**#004**

**SIDNEY CITY HALL REMODEL**  
**Sidney, Montana**

REQUEST:

Provide cost to adjust the water entry and add an irrigation line per the attached revised drawings.

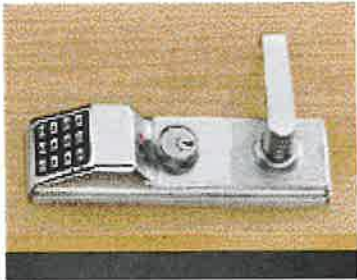
Provide electronic locksets per the attached cut sheets for doors 108C & 129.

DEBIT: **\$2,394.00**  
CALENDAR DAYS: **0 days**
